PLANNING COMMISSION AGENDA

Planning Commission Meeting
6:00 PM Thursday, January 12, 2017

VILLAGE OF SOUTH LEBANON MEMORANDUM

TO: Planning Commission
FROM: Jerry Haddix, Village Administrator
RE: Case 17-02P, Site Plan Review for Patel Convenience Store
DATE: January 9, 2017

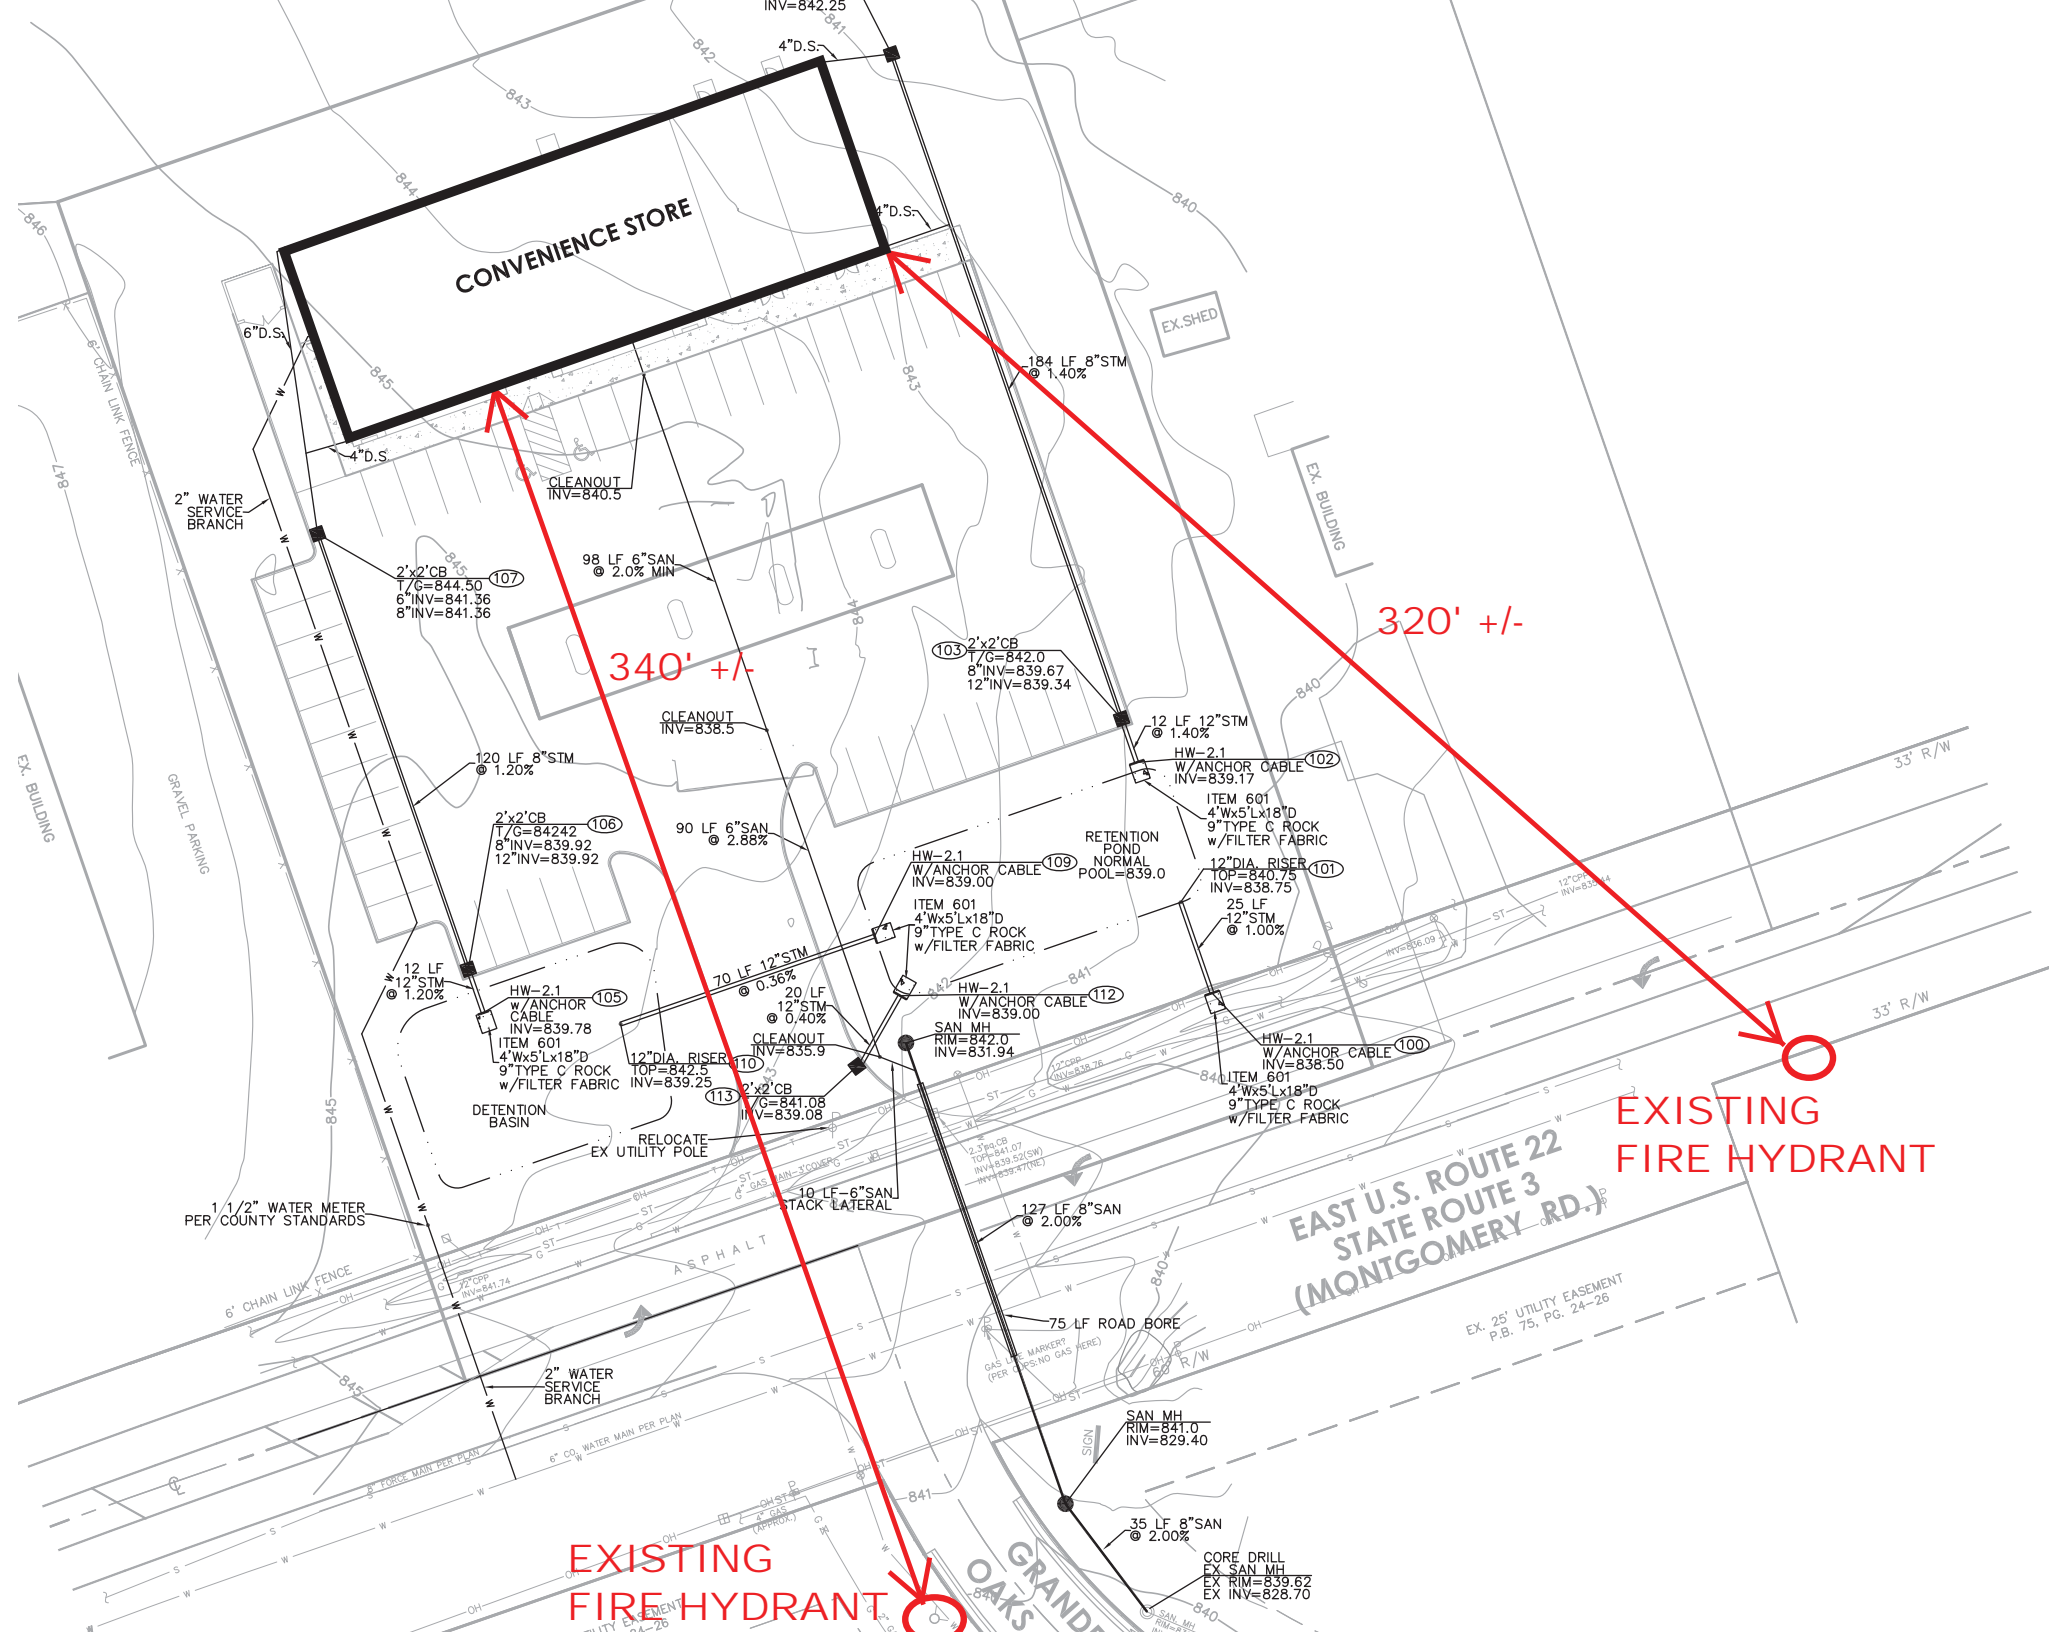
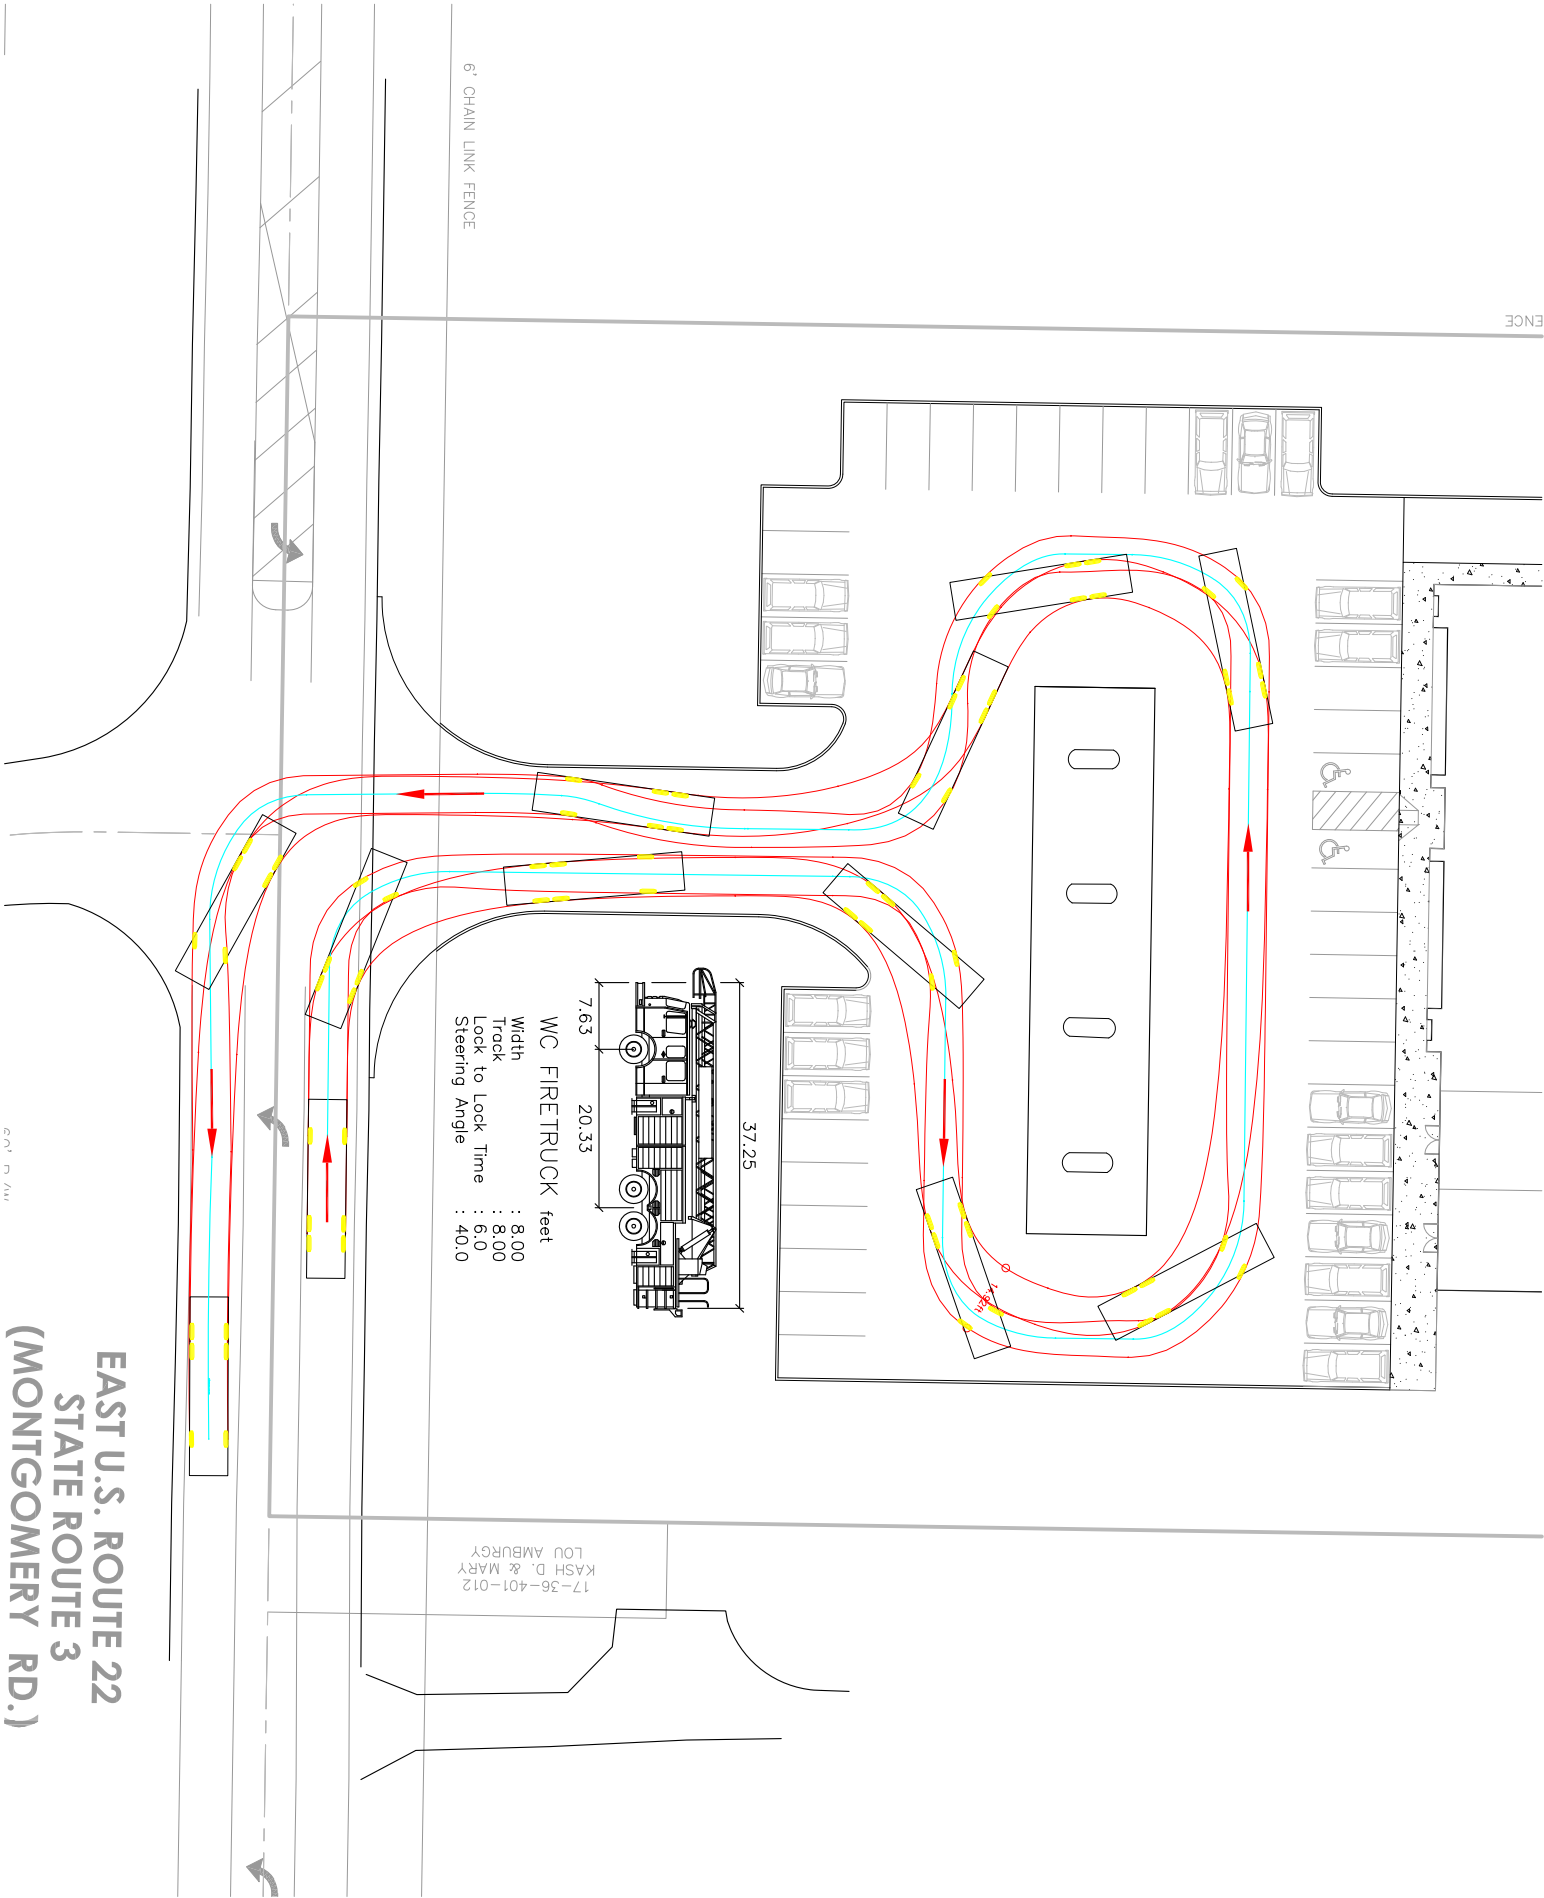
At this stage the developer needs to show fire hydrant location and show that we will have enough room to get a Ladder Truck and a Fire Engine around the parking lot with cars parked in the parking spaces. Then we will need to have a set of drawing for the building. So I can go over those for further questions.

Pursuant to your comments, attached is a diagram modelling how a ladder truck will be able to maneuver around the proposed parking area. Also attached is an exhibit showing the locations of nearby existing fire hydrants located within 400 feet of the proposed building. Please advise if these hydrants will provide sufficient coverage.

Drawn By	BC	Date	11/02/16	Project No.	06308.03	Sheet No.	C100
Project Mgr.	JW	Scale	1" = 30'	Points D.B.	0630803 TBC

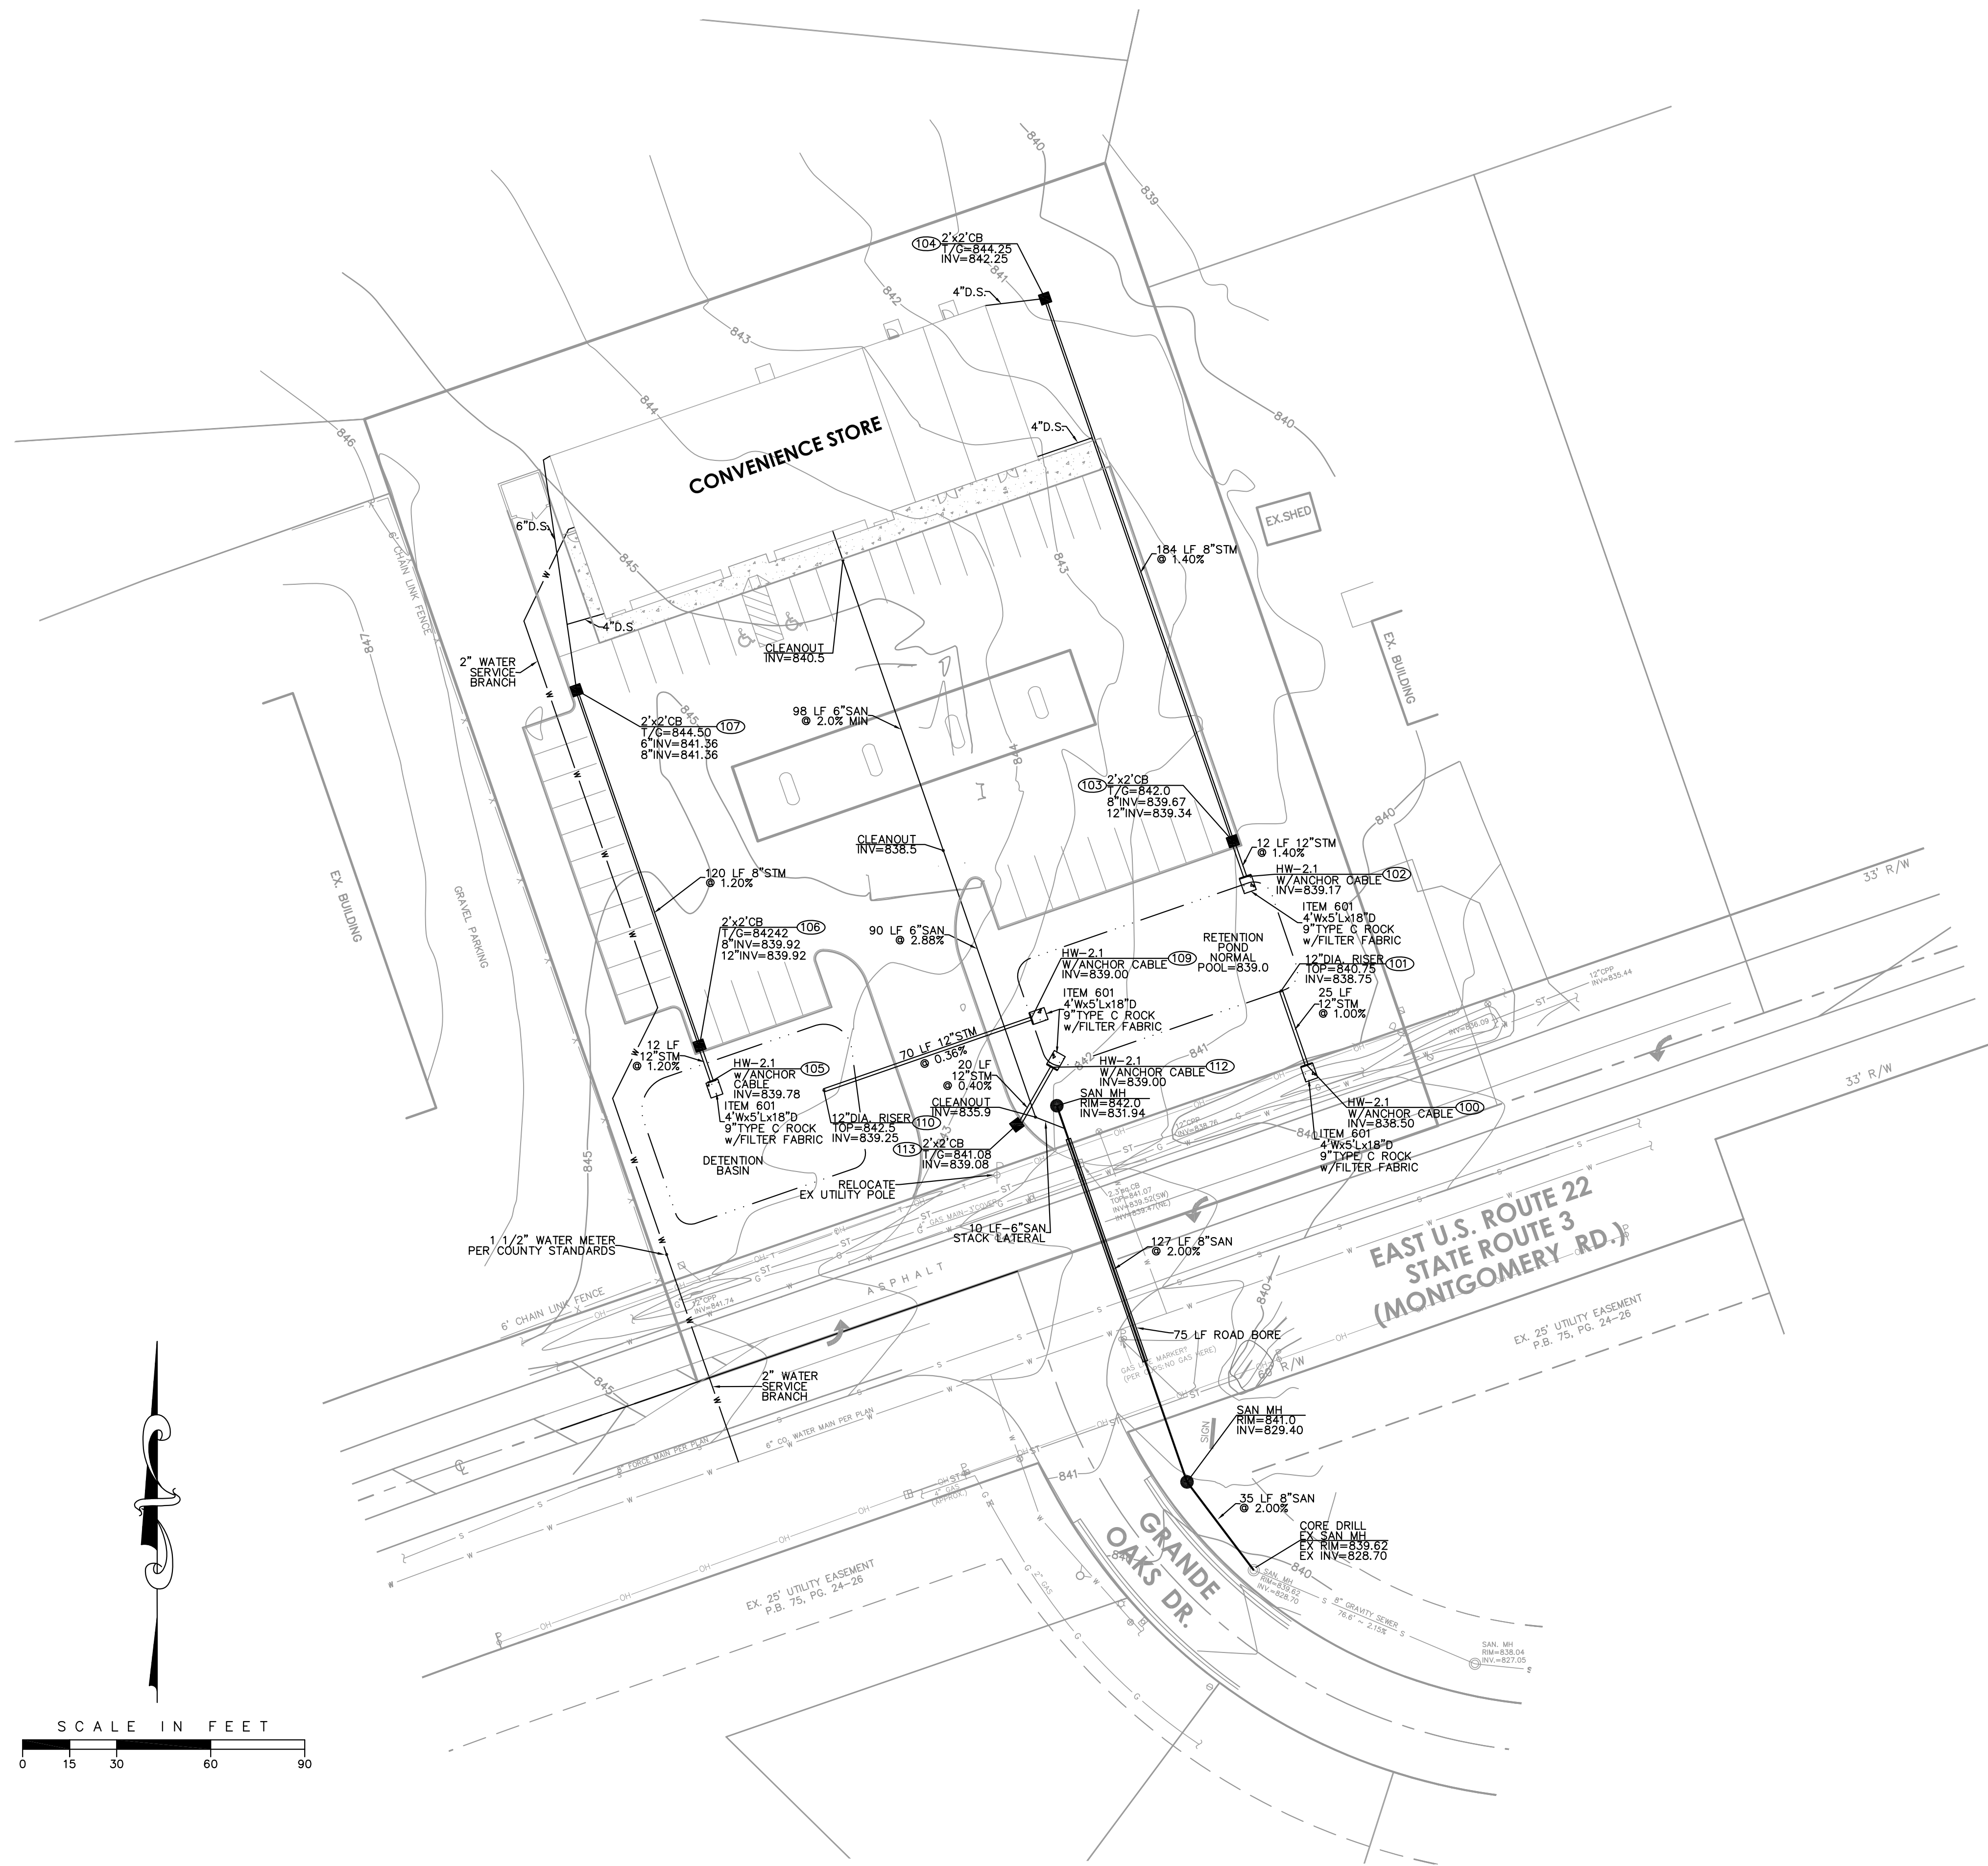
11. All Other Items		
General Comments	<p>Note: The sanitary sewer connection is not approved as a decision is pending on whether Warren County or the Village of South Lebanon will service this site with sewer.</p> <p>Sheet C100</p> <ul style="list-style-type: none"> • Please provide the turn lane length calculations. • Add the appropriate left turn sign indicating the new turn lane on SR 22/3. <p>Sheet C101</p> <ul style="list-style-type: none"> • Note #8 – the project is not within the City of Norwood • Note #14 – please update the note to reflect ODOT's current spec 611 not 603. • Please indicate the pavement composition around the gas pumps. • CB #106 T/G 842.42 • The pavement slope in the handicap parking area is at 2.05%, it must be 2.0% or less. • Should the top 3/8" holes in Detail 101 should be 839.50? <p>Sheet C102</p> <ul style="list-style-type: none"> • SWPPP Note #2 – The total site area is 1.865 acres. <p>Sheet C103</p> <ul style="list-style-type: none"> • Call out what to do with the existing water service for the property.
